Report of Dam Safety Assessment of Coal
Combustion Surface Impoundments
NRG Energy
Huntley Generating Station
Tonawanda, NY

AMEC Project No. 3-2106-0194

March 2013

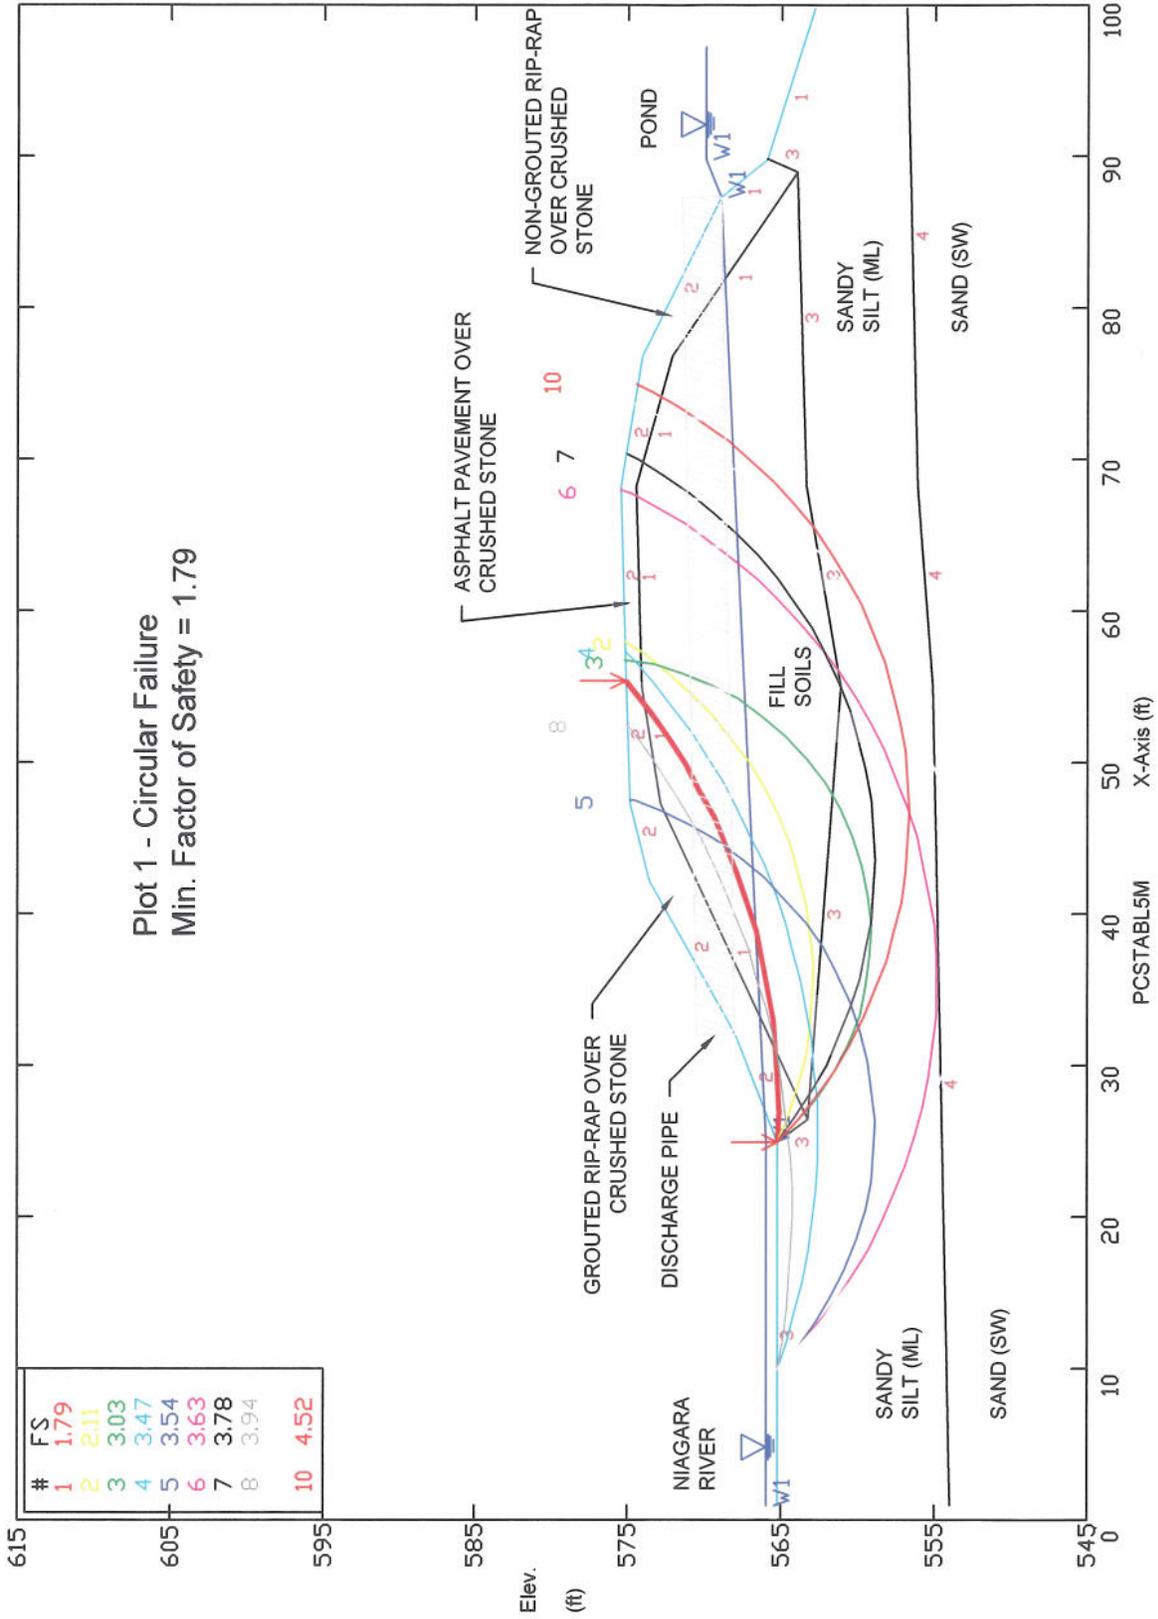
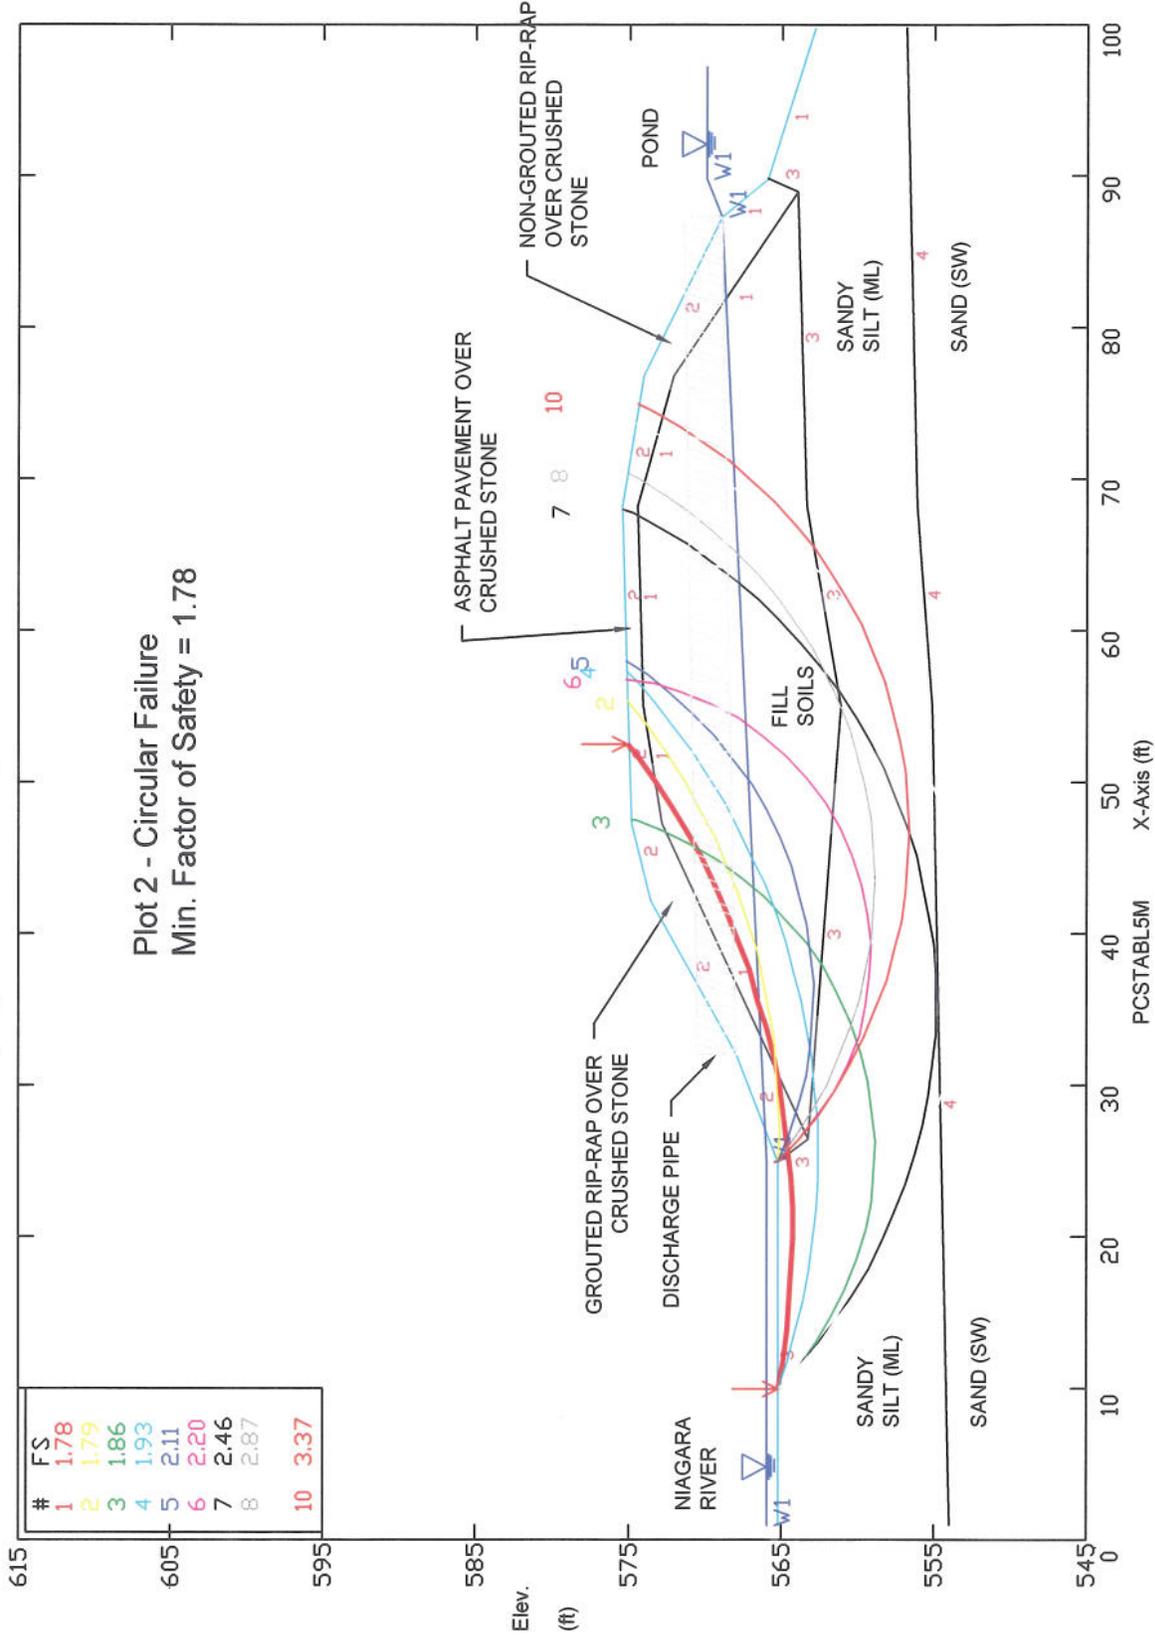
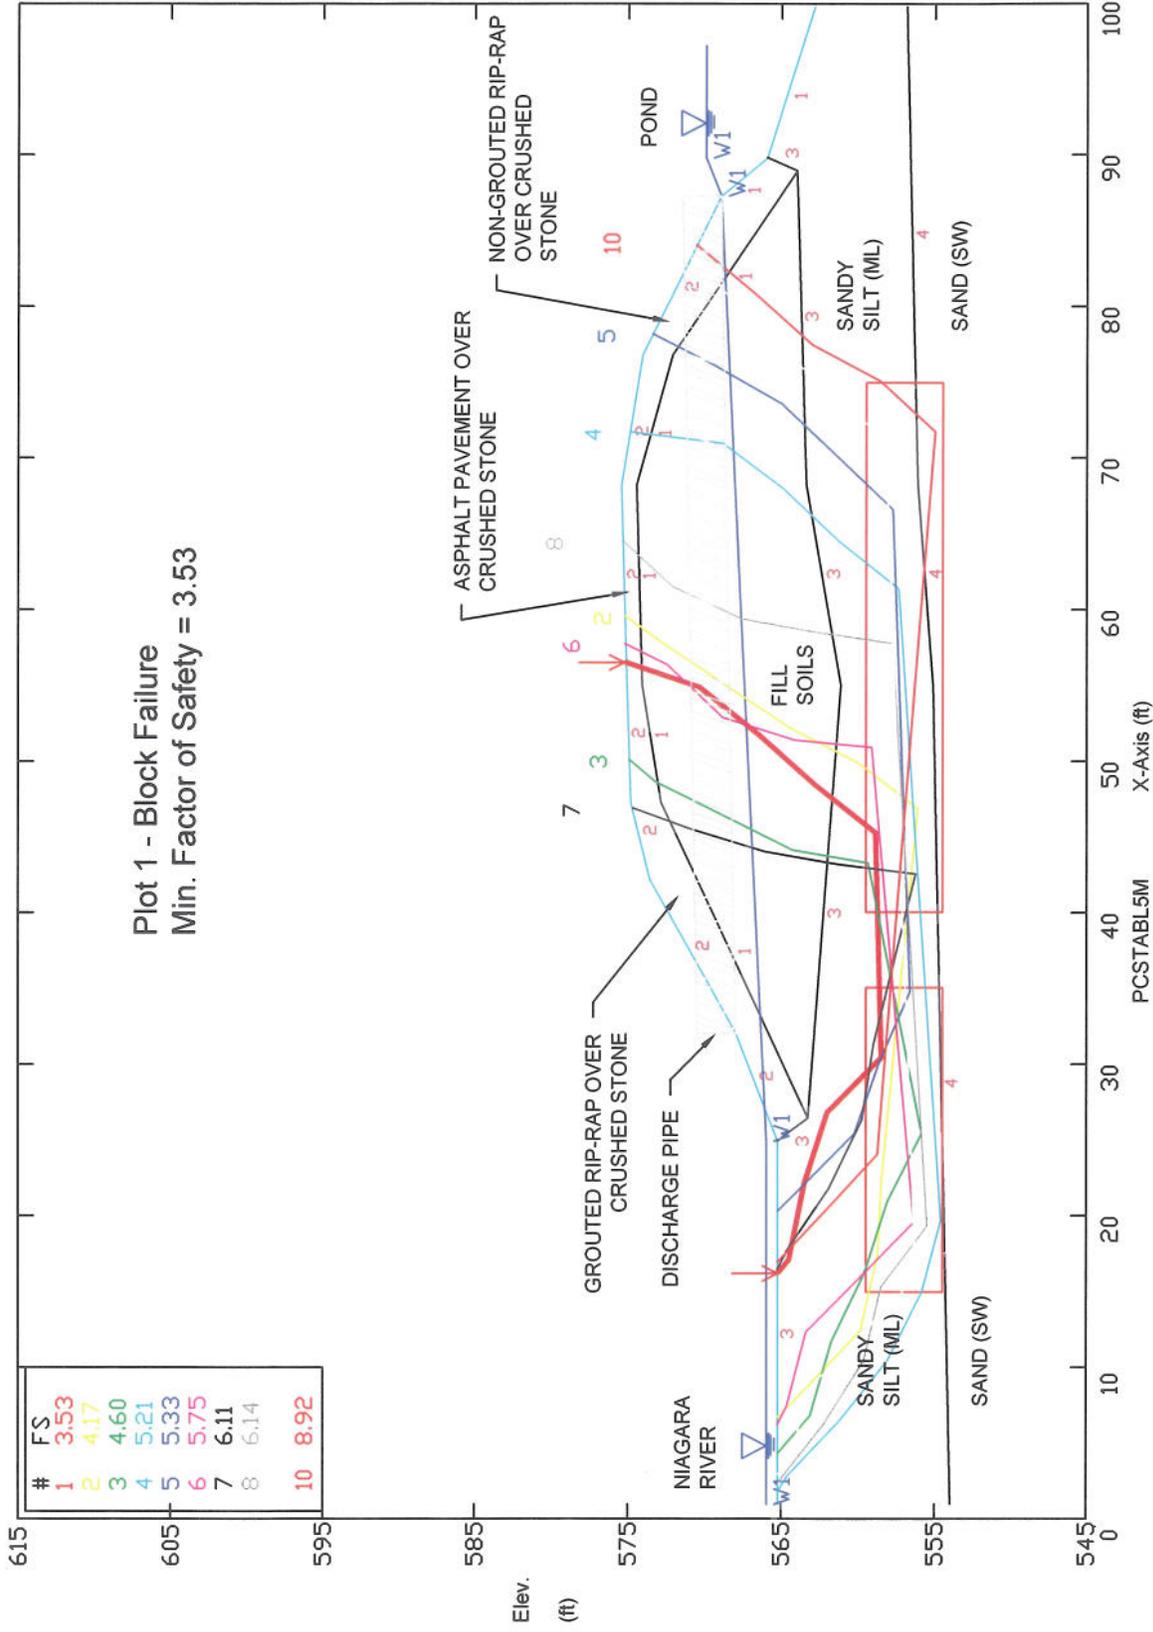
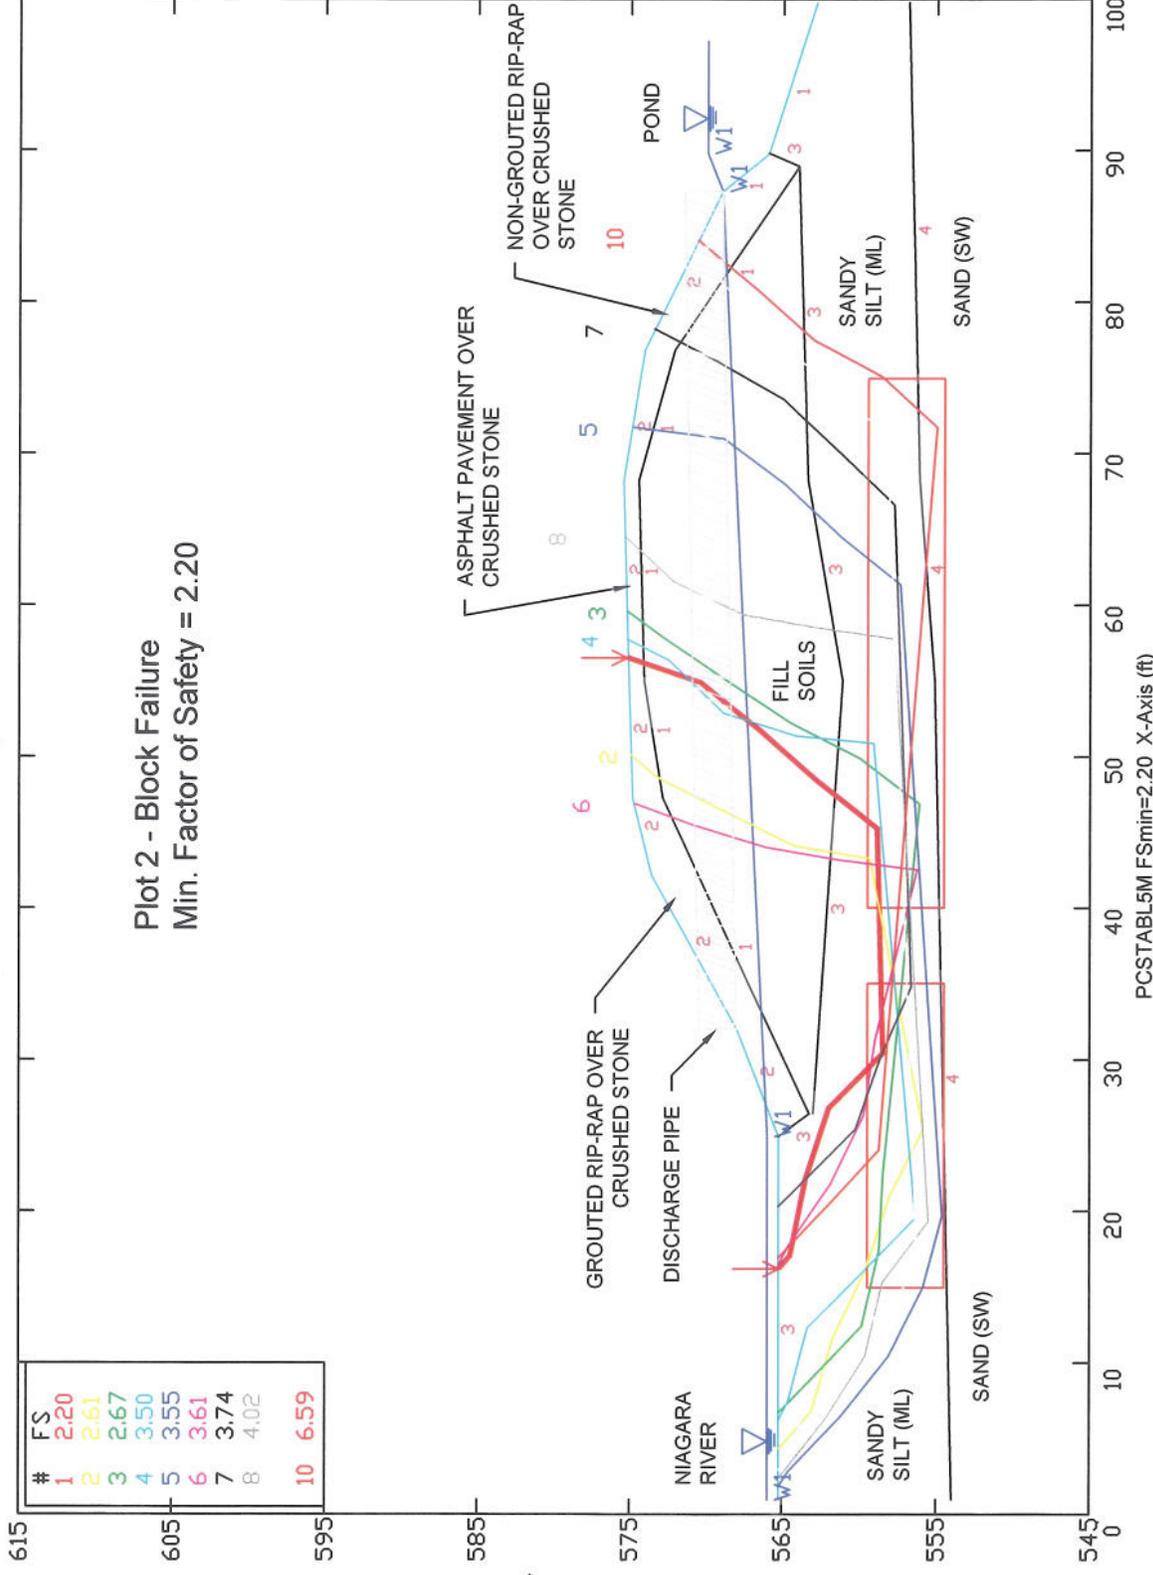
The report notes the side slopes are generally observed to be 3H:1V. Measurements on the submitted stability analyses plots indicate a top width of about 20 feet with 8 to 10-foot wide slightly sloping shoulders and side slopes of 3.5H:1V on the downstream slope and 3H:1V on the upstream slope. Sheet 3 of the design drawings for the "Intake Modification" shows the section for the South Pond outlet, but the design slopes are not clearly labeled/represented.
